MODIFICATION RECOMMENDED

N1921A-02

Agilent P-Series Wideband Power Sensors

Loose bulkhead (N1920-60004)

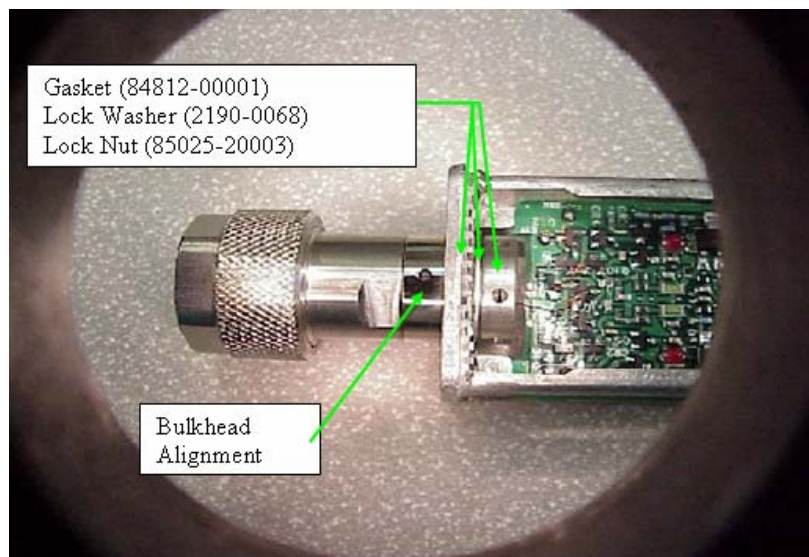
Loose bulkhead (p/n: N1920-60004) for P-series wideband power sensor built in US. Kindly send it to local service center for rework.

1. Screw lock nut 85025-20003 onto threaded end of bulkhead assembly. Apply loctite (0427-0231) on the first, second and third threads of the end of the bulkhead (as shown in the figure below):

2. Torque lock nut to 28 in. -lbs. with T-314592.

3. Calibrate the unit after the above changes are applied.
